8. Well Name and No.  
CEDAR CANYON 23 FEDERAL 5H9. API Well No.  
30-015-43282-00-X110. Field and Pool, or Exploratory  
PIERCE CROSSING11. County or Parish, and State  
EDDY COUNTY, NM**SUBMIT IN TRIPLICATE - Other instructions on reverse side.**

OXY USA Inc. respectfully requests approval for the following changes to the approved permit:

Batch drill the Cedar Canyon 23 Federal #5H and Cedar Canyon 23 Federal #4H with skidding operations

## PECOS DISTRICT CONDITIONS OF APPROVAL

**Wellhead for pre-set surface casing.pptx**  
34K

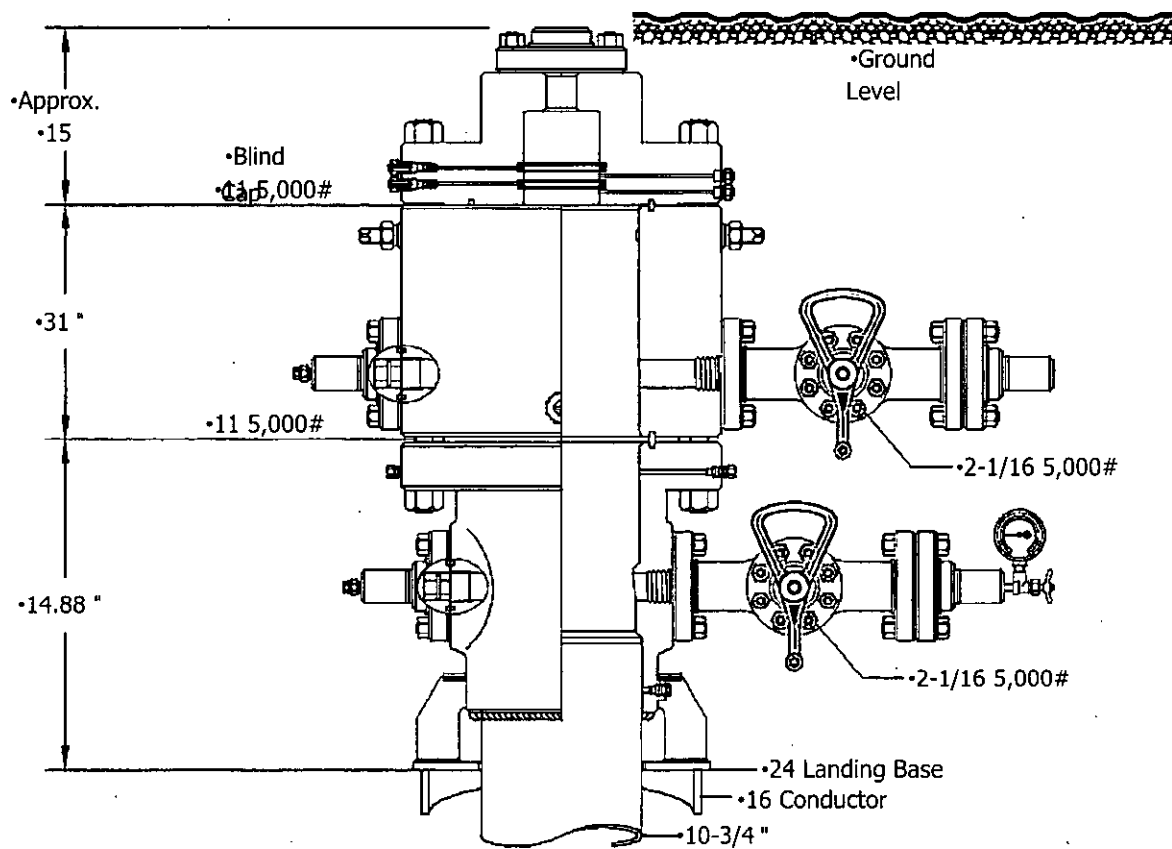
We will use a blind cap to prevent anything from falling into the well and between skids to secure it.

The operator has proposed to drill multiple wells utilizing a skid/walking rig. Operator shall secure the wellbore on the current well as proposed after installing and testing the wellhead, by installing a blind flange of like pressure rating to the wellhead and a pressure gauge that can be monitored while drilling is performed on the other well.
